# **NORTHUMBRIAN WATER**

# **DRAFT DETERMINATION COMPANY REPRESENTATION**

## DRAFT DETERMINATION - COMPANY REPRESENTATION

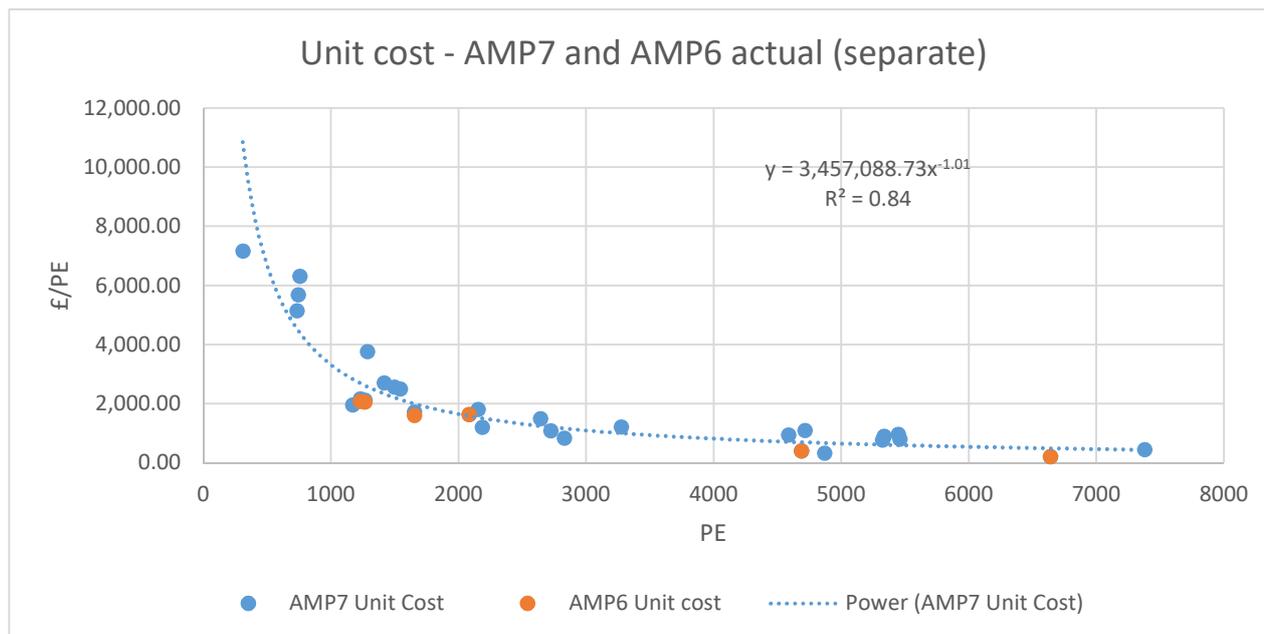
A further key factor not reflected in Ofwat's cost models is how efficiently sites are currently designed in relation to complying with current permits – with leaner sites requiring a greater uplift to meet tighter future permits. In particular, when considering solutions for additional nutrient removal, it became apparent that many of the settlement process units at our sites, whilst performing well under their current permit, could not accommodate either chemical treatment or co-settlement of solids from the tertiary treatment processes. The existing settlement units could not cope with the chemical sludge and could not be effectively de-sludged as frequently as these new processes require. We therefore costed to replace all horizontal flow or pyramidal settlement tanks with radial flow units where they are integral to the nutrient removal process, this could be primary, secondary, or in some cases both. When we have checked with other companies applying similar processes, they either have radial flow units already in place or are installing them similar to how we have costed. This has been confirmed by our consultants Stantec who have been working with other water companies.

While the model Ofwat has applied does take some account of both the size of the works and where the permit standards are more onerous (less than 0.5 mg/l), we would question how well this approach takes account of the very low end of the population equivalent (pe) range (i.e. very small sites).

The majority of the works we are targeting in AMP7 are **less** than 5,000 pe. We note that there are significantly increased knock on costs associated with smaller, rural works due to the need for:

- improved access for chemical deliveries, and sludge transport; and
- increased pressure on existing assets
